PRIVATE PLAN CHANGE 40

AGENDA – VOLUME 2

CLAYDEN ROAD, WARKWORTH

WARKWORTH LAND COMPANY, WHITE LIGHT TRUST LTD, KAURILANDS TRUST LTD, ROB MILLS & P & L RICHARDS

IXXX.9.2 Precinct Plan 2

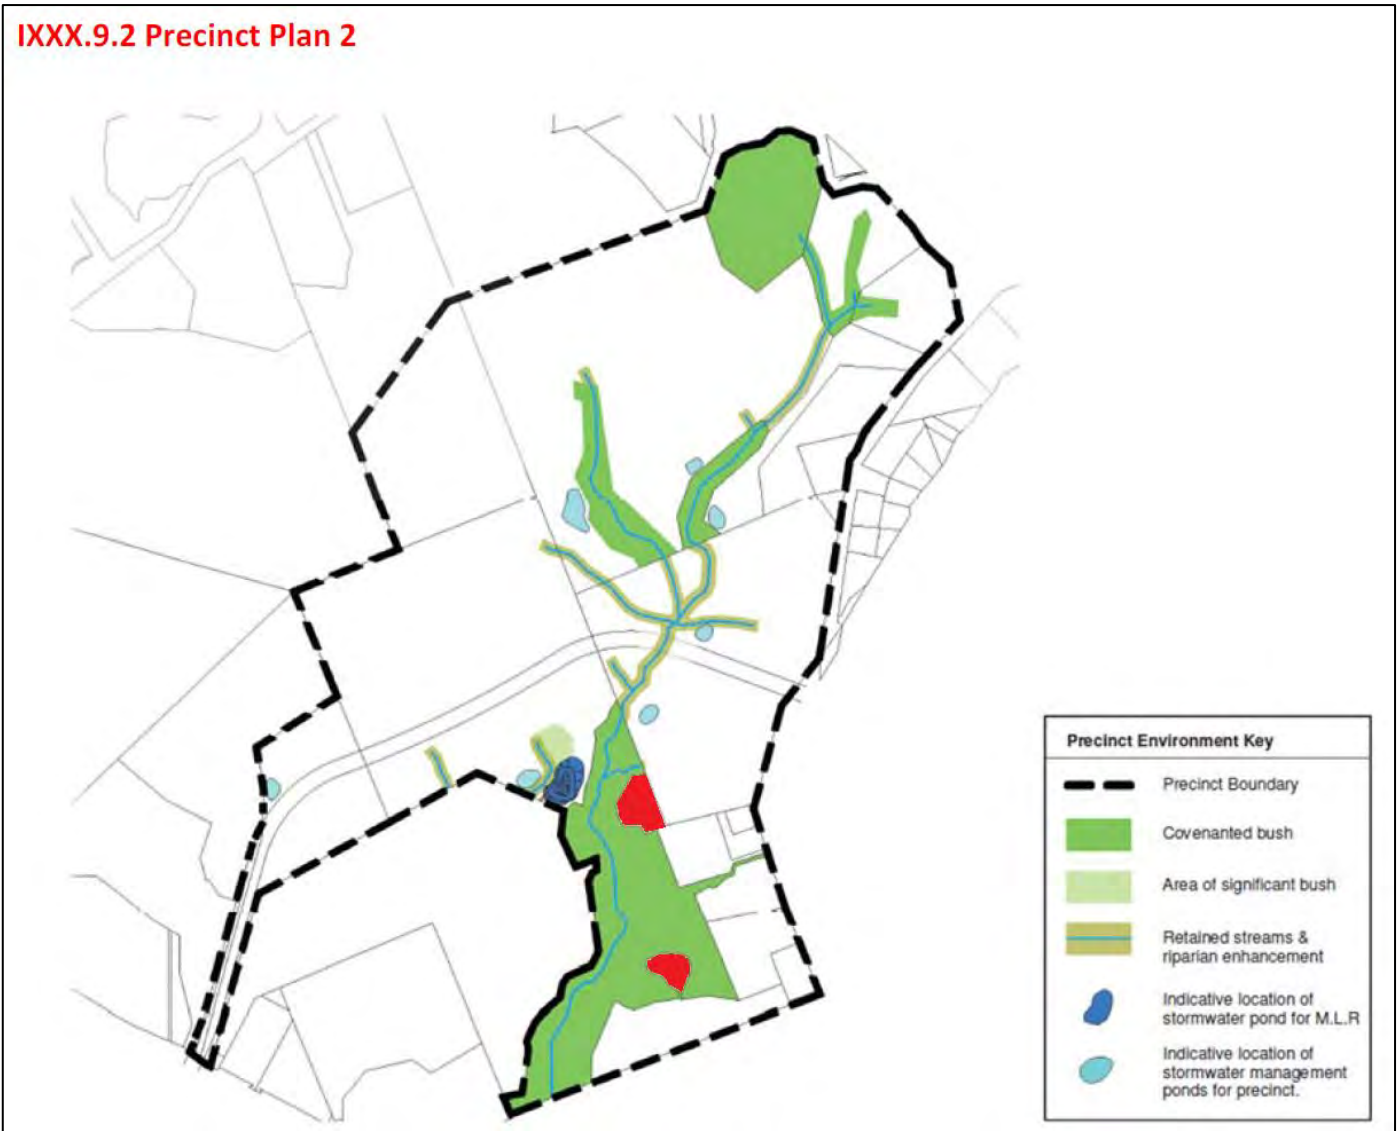
- 4.6. We are especially concerned about two 'keyhole' areas shown in red on the annotated version of *Precinct Plan 2* below. With the high value native bush essentially encircling these areas, the potential for impact from land use intensification is high, particularly on kauri within the covenant. We submit that instead these two areas should be retired and included with the 'Protection areas (not for development)' zonation from the Structure Plan, so that they can provide a buffer to mitigate detrimental effects from the adjacent development. 13.3

Map showing in red the 'keyhole' areas which QEII submits should be given status of 'Protection areas (not for development)'

Figure 1. The indicative large open space circled in blue is unsupportable for acquisition. Part of the indicative open space circled in pink is likely unsupportable for acquisition.

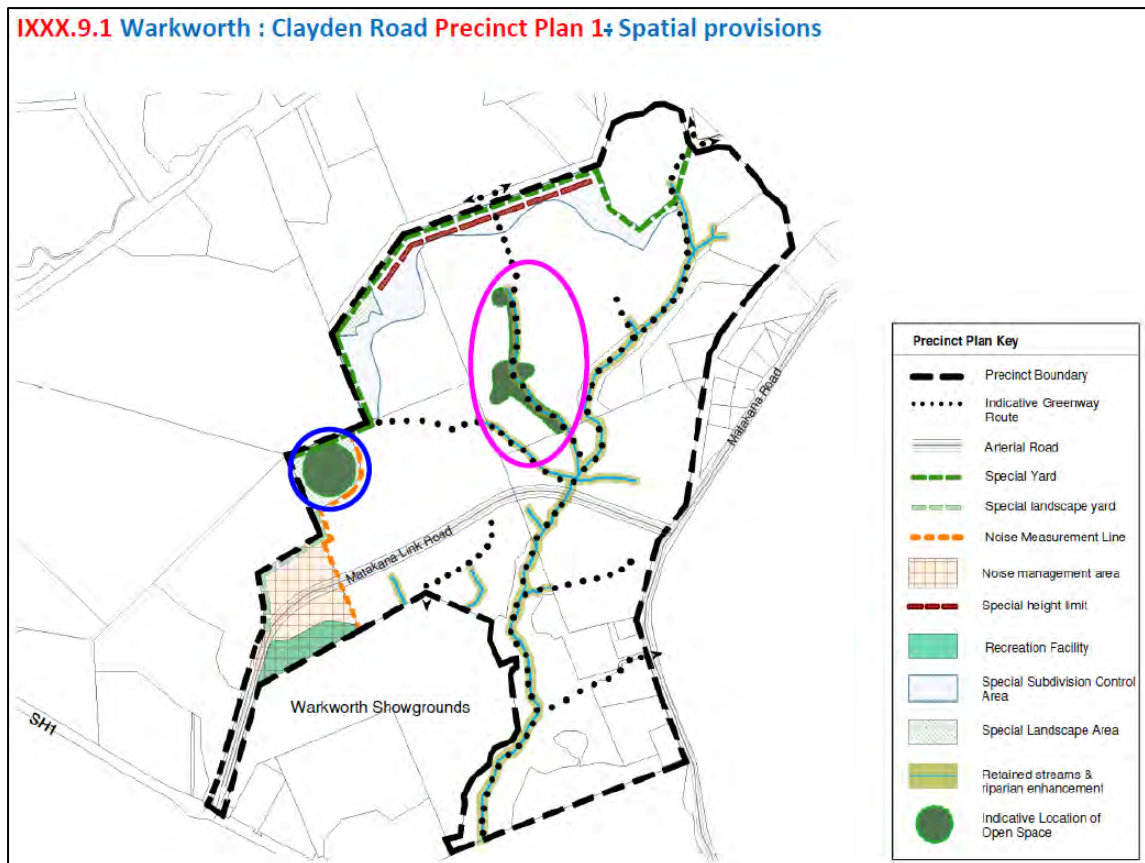
IXXX.9.1 Warkworth: Clayden Road Precinct Plan 1: Spatial provisions in the Warkworth Plan Change post Submission Updated v2 (23-06-20) (002) shows a large indicative open space (refer Figure 1) that is inconsistent with the council's Open Space Provision Policy (2016) and is not supportable for acquisition by the council (assuming the applicant is expecting the council to acquire the land).

Precinct Plan 1 also shows a linear open space including an indicative greenway route with several nodes attached to it (refer Figure 1). Some of this area is likely unsupportable for acquisition but requires further investigation through the subdivision and resource consenting processes.

Figure 1. Proposed precinct sub-catchments

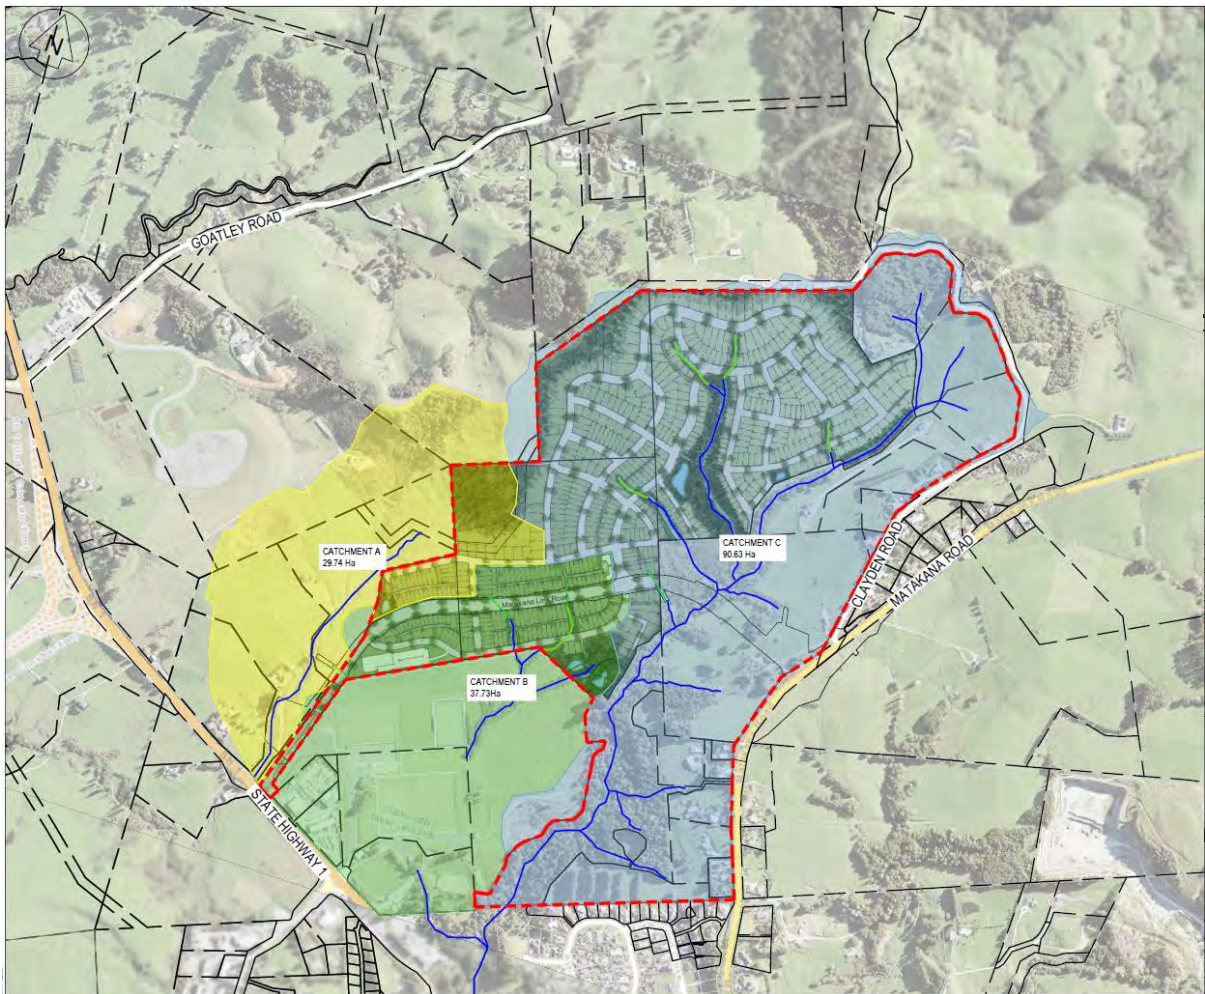
- 2.1 The proposed precinct area includes three sub-catchments. Catchment A discharges to an existing culvert beneath State Highway 1 (**SH1**) which is commonly referenced as Culvert E350. The eventual discharge location of the other remaining sub-catchments includes a culvert beneath the Hill Road intersection near the Warkworth Town Centre. Sub-catchments are indicated in Figure 1.

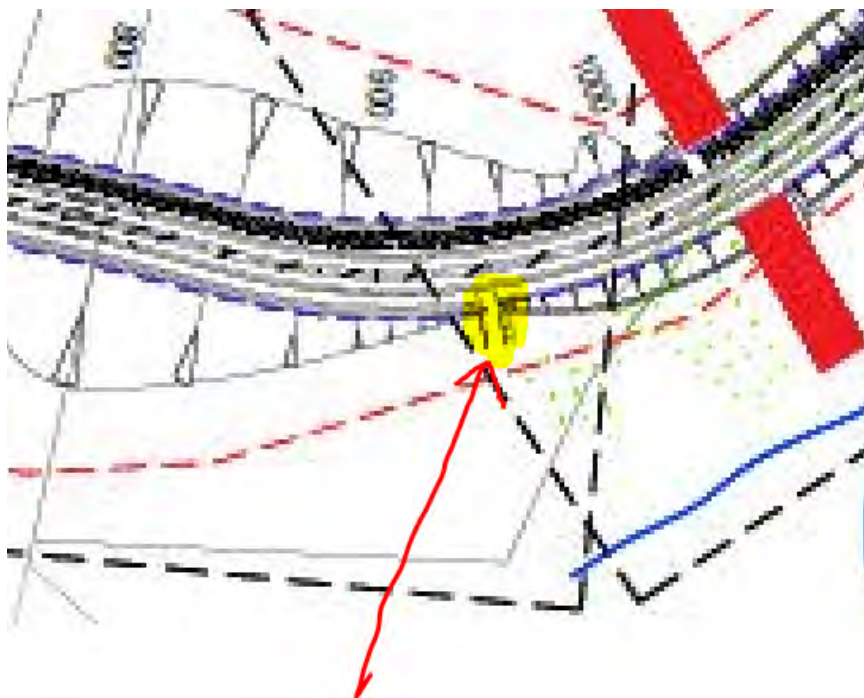
I note that the plan of the indicative intersection locations included with the private plan change request (see link below) includes what seems to be a direct access point to the subject land. I have zoomed in and highlighted this on the map below.
